**Report to
Development Permit Panel**

To: Development Permit Panel
From: Jean Lamontagne
Director of Development
Date: August 10, 2006
File: DP 06-325113
Re: **Application by Am-Pri Construction Ltd. for a Development Permit at 7060 Ash Street (formerly 7040 and 7060 Ash Street)**

SITE PLAN
SCALE: 1/8" = 1'-0"

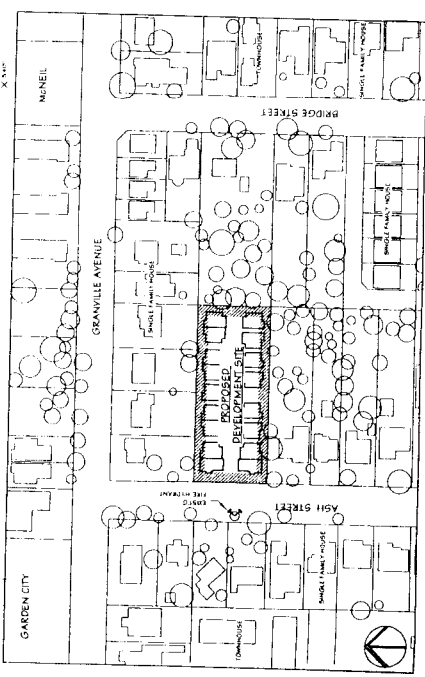
VARIANCE FROM
6M TO 5.2M
FOR ENTRY PORCH

VARIANCE FROM
6M TO 1.52M
FOR GARAGE/
RECYCLING ENCL.

VARIANCE FROM
6M TO 5.2M
FOR ENTRY PORCH

3. The "Richmond Zoning and Development Bylaw No. 5300" is hereby varied to:
 - a) Reduce the front yard setback from 6 metres to 1.52 metres for a garbage enclosure and a mailbox enclosure; and

- b) Permit 0.8 metre single-storey entry porches to project into the front yard setback.
4. Subject to Section 692 of the Local Government Act, R.S.B.C.: buildings and structures; off-street parking and loading facilities; roads and parking areas; and landscaping and screening shall be constructed generally in accordance with Plans 1 to 7 attached hereto.
